SS 3142-FTL J1939 CAN issues for vehicles equipped w/ Bendix Side Radar w/ expanded field of view

NOTE: Freightliner Service Bulletin 54-366 published on 10/29/2024. Please refer to the Service Bulletin for instructions on addressing the containment provided in this Service Solution. Also refer to the Service Bulletin for any future concerns associated with the information provided in this Service Solution.

Applicable Vehicles

This solution targets New Cascadia vehicles built from 9/9/2019 with Cummins engine, automated or Allison transmissions, Bendix side radar connected to the J1939 500K back bone and customer access RP1226 connections (typically found in module 6TS or 786).

Figure 1

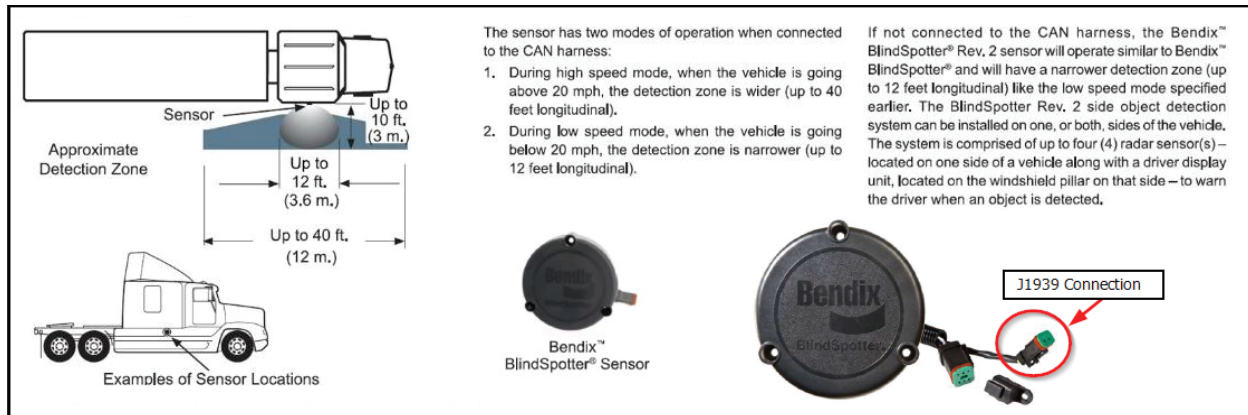
The Bendix Side radar revision 2 uses J1939 to monitor vehicle speed. The containment would include unplugging only the 2-pin J1939 connection to the side radar. Unplugging of the J1939 allows the Bendix side radar to function like the earlier version. The only function difference with the J1939 unplugged relates to vehicle speed. With the J1939 unplugged, vehicle speed above 20 MPH, will not expand the detection zone to up to 40 feet, but rather maintain the roughly 12-foot detection zone as pictured in the Figure 1 below.

1. There will be a 6-pin connection and 2-pin connection at the Bendix side radar. Only unplug the 2-pin J1939 connector going to the side radar.
2. To eliminate any chance of contamination from entering both the plug and receptacle ends of the J1939 connections, connectors with seal plugs will need to be added to each end. Use the following parts to seal both ends of the connector.
